Due Diligence Report Bishkek-Torugart Road Rehabilitation Project Project 3 (km 479 to 539)

Torugart Customs Post Approach Lanes.

Supplementary to Environment Impact Assessment Report (March 2015)

Figure 2 BNT3 Layout Options for Parking and Queueing near Torugart Customs Post

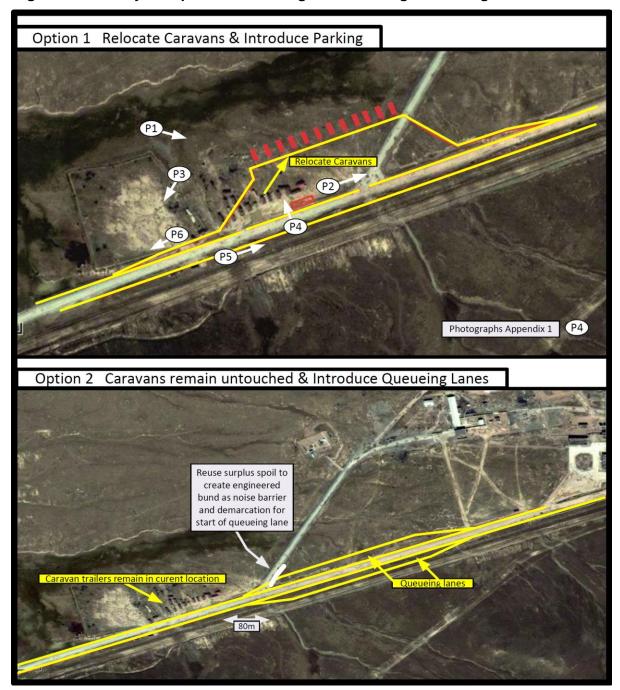
24. The joint review has concluded that alternative provisions are required and that additional parking lanes are a better option for vehicles traveling from Kyrgyzstan to China at km 531.

25. Therefore the Contractor CRBC prepared a design change, providing for additional 3.5m wide lanes over 300m just west of the Torugart Customs Post for queueing of vehicles entering China from Kyrgyzstan. Along the distance of additional lanes there is no any social facility just an empty and tenantless area. All these additional lanes area is within ROW and there is no need to any land acquisition (road is category III, width of ROW is 28m).

26. The conceptual design for the parking lanes is shown in Figure 2, Option 2. The new queueing lanes will abut Torugart Customs Post and the Customs Service, in turn, will equip the terminal and build a platform for vehicles entering in Kyrgyz Republic from China. At the entrance to the Kyrgyz Republic vehicles carrying freight will also pass over a weighbridge control point mounted within the improved customs terminal.

28. Additional measures such as installation of a noise barrier has also been considered. One option would be to collect spoil material from construction activities and form an engineered bund (say 1.5m high as shown in Figure 2, Option 2) to act as a noise barrier. The bund can be contoured and compacted to reduce the wind shear on the surface and the dust generation can therefore be reduced. Based on observation at the site and professional experience the separation distance is >80m and any dust generated after construction should not be noticeable above the existing background dust levels. A compacted bund can be built with say 45 degree side slopes for a stable angle of repose and the top can be rounded off to reduce wind shear. To achieve a 1.5m height the base would be about 4m to 5m wide. The surface can be compacted with surplus stockpiled topsoil. The contractor will construct the noise barrier.

Appendix 3 Explanation of Drawings

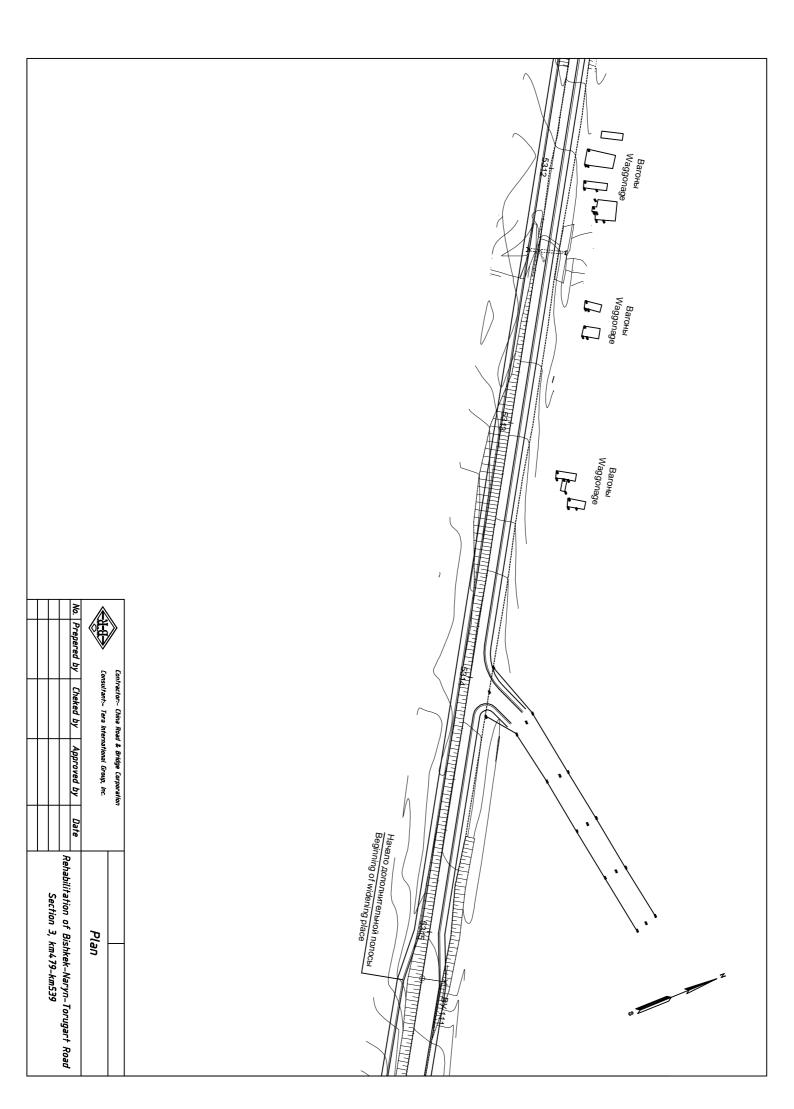
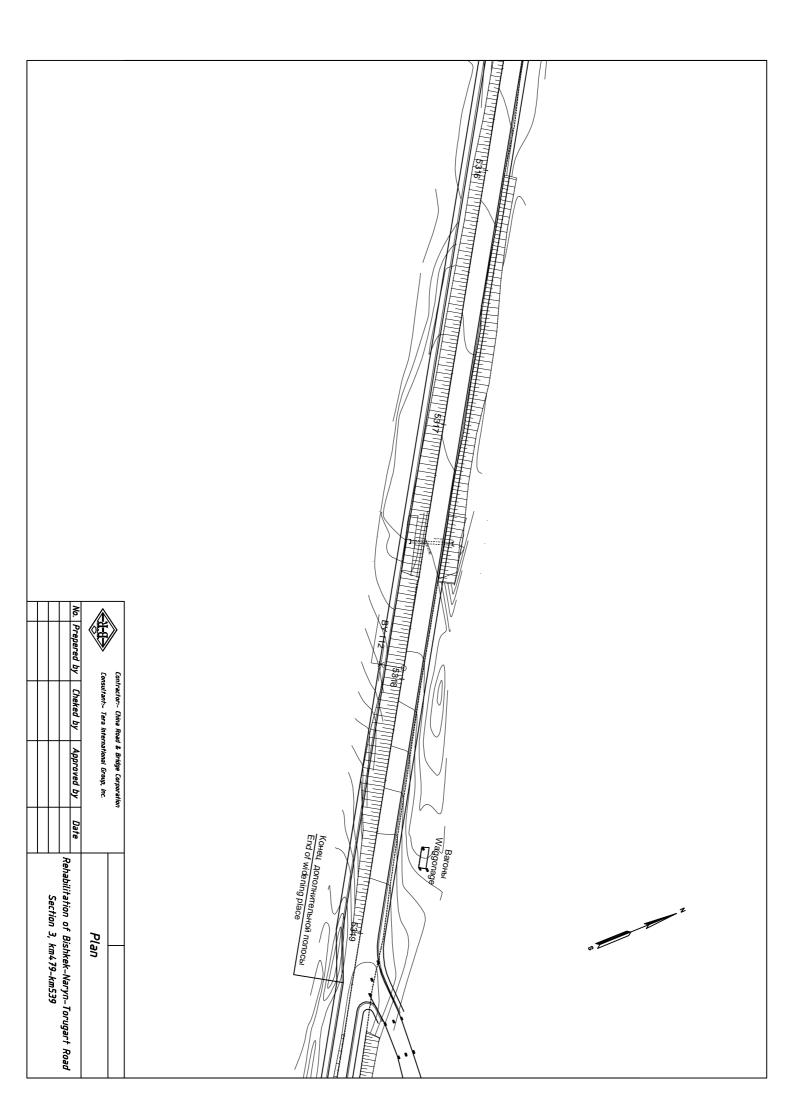
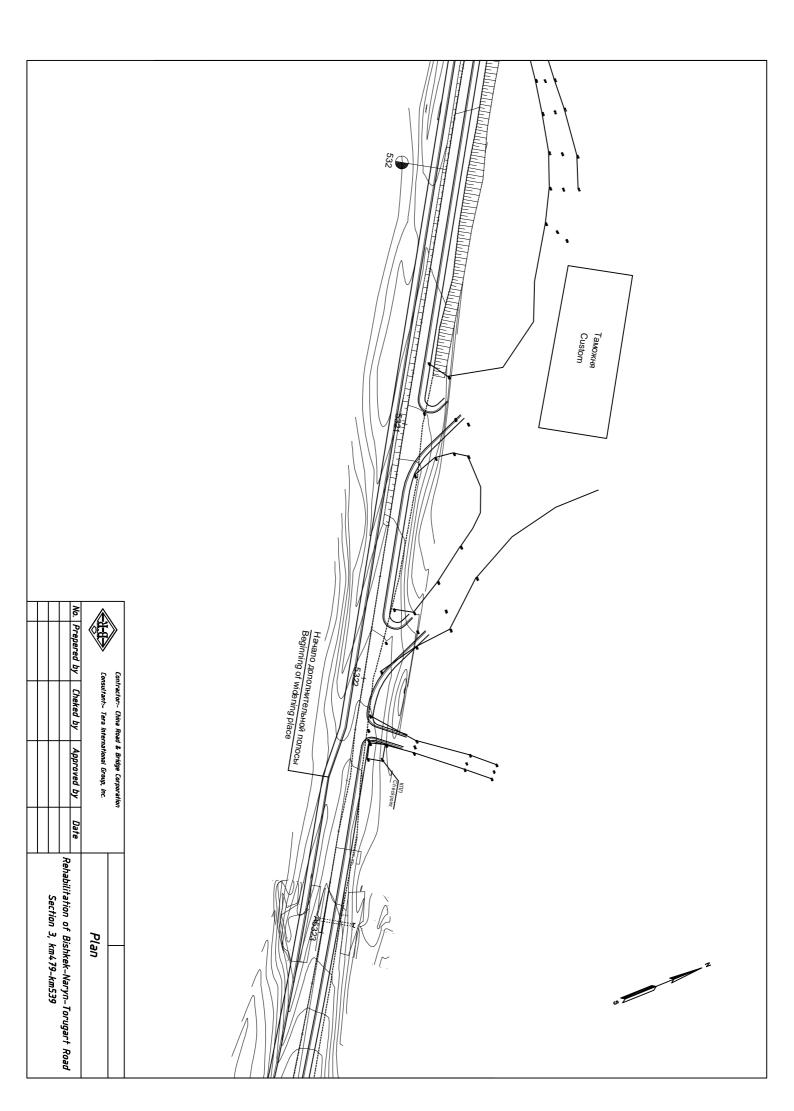
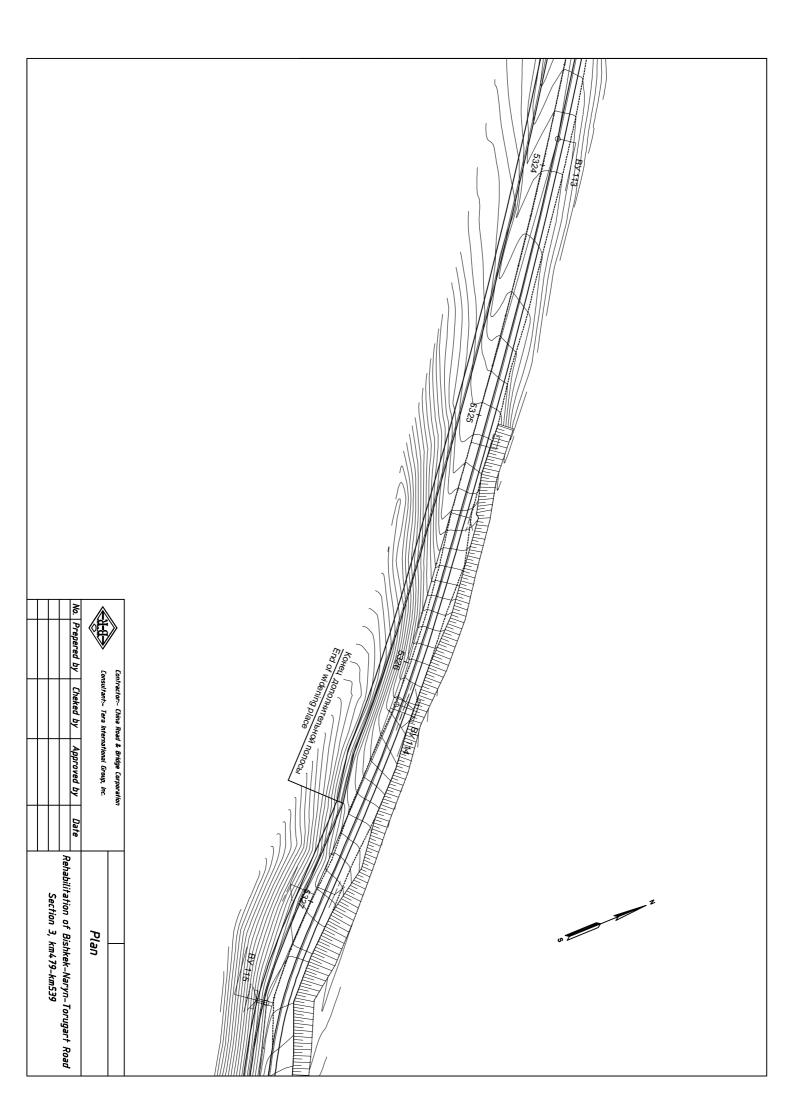
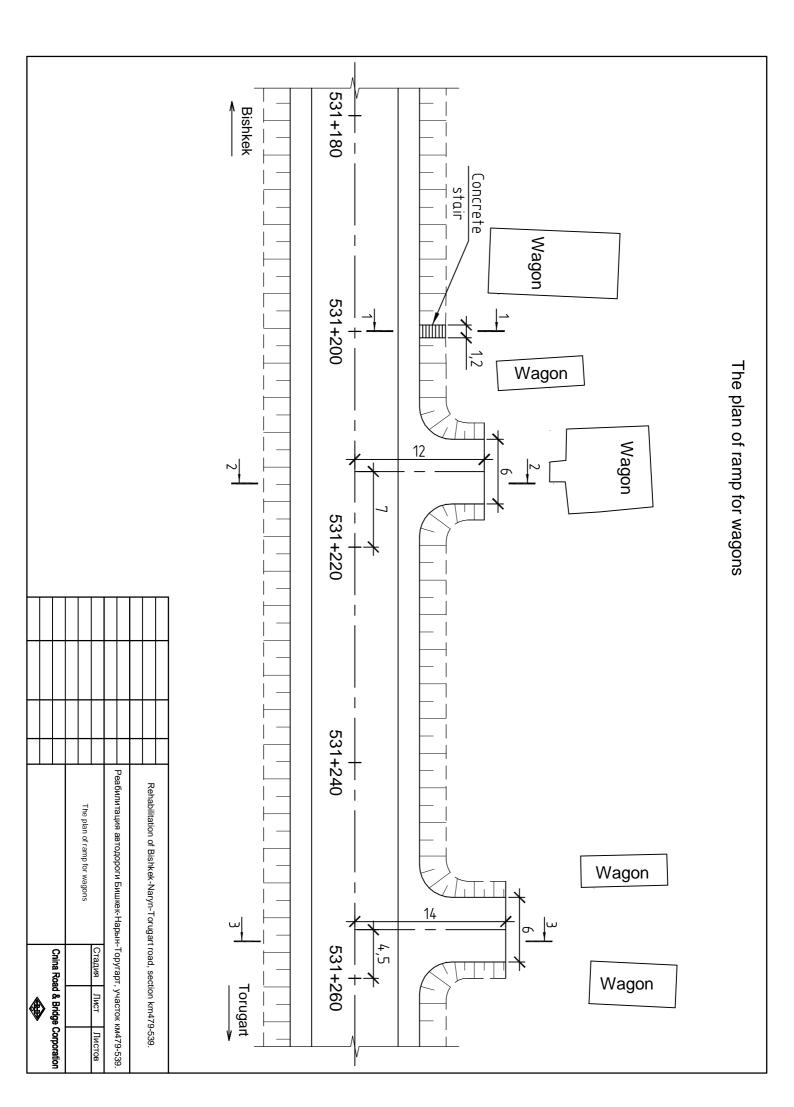
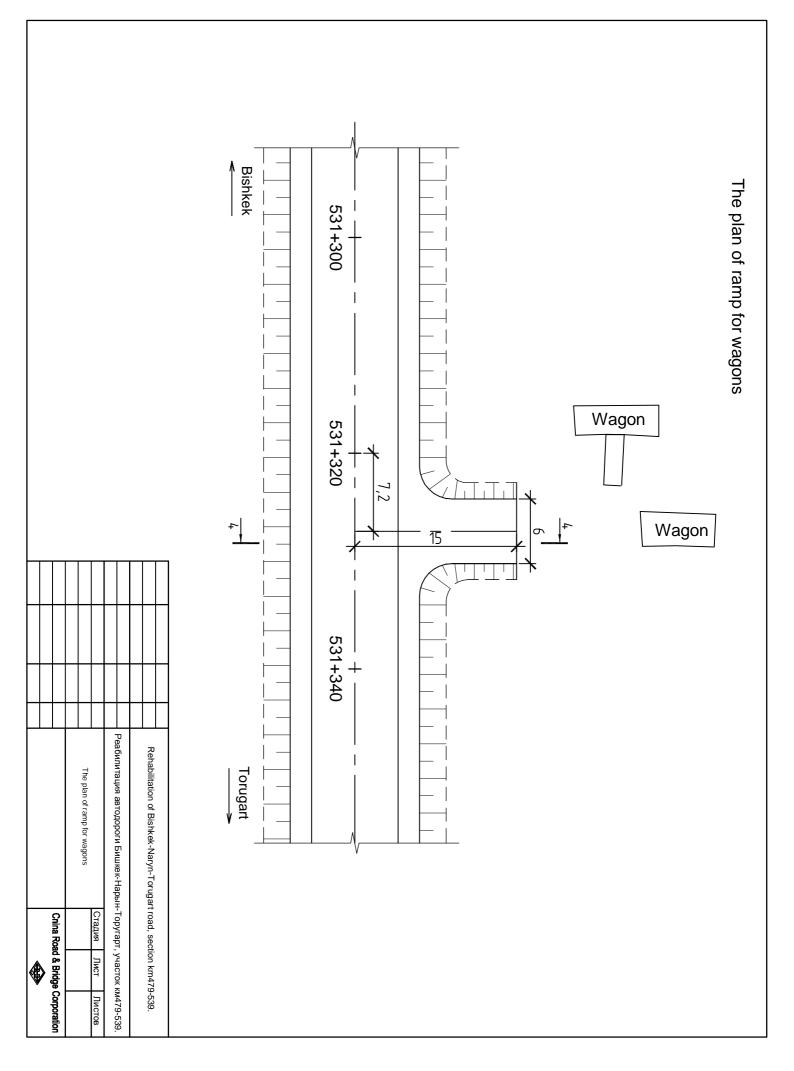
To facilitate access to the existing trailers, ramps and stairs will be constructed as detailed below. The drawings show that the access to the trailers will not be affected during construction, and will be enhanced following construction. The drawings for the ramps and stairs are necessary because the height of the alignment is being raised. The alignment is being raised to reduce the potential of frost-heave cracking in the roadbed. The end result will be that inhabitants of the trailers will not be adversely affected by the road construction and access to the trailers will be enhanced because of the addition of designated parking areas and access ramps and stairs. This will facilitate improved livelihoods by reducing dust and congestion in the area.

The fifth drawing indicates the locations of the concrete stairs and two asphalt ramps leading to the trailers. The paved road will be about 1.5 meters above the area where the trailers are sited. As noted above, the alignment height has been raised to reduce the potential for frost-heave cracking.

The sixth drawing shows the location of a third ramp that is about 9 meters in length and built at the ratio of 1:4. The three ramps will ensure access to the trailer area. The ramps will also facilitate movements during wet and cold periods.

The seventh drawing shows the plan for the concrete stairs. This will enable truck crews to leave their parked vehicles and visit the trailers for meals and refreshments.

The eighth drawing provides more detail on the stairs including eight steps and a length of 2.4 meters. At the bottom of the stairs, there will be a concrete slab that will provide stability during wet and cold periods.

The ninth drawing presents more detail on the three ramps. The ramps will be between 5.75 and 7.5 meters from the nearest trailers. This will provide sufficient space for access to and from the trailer area.
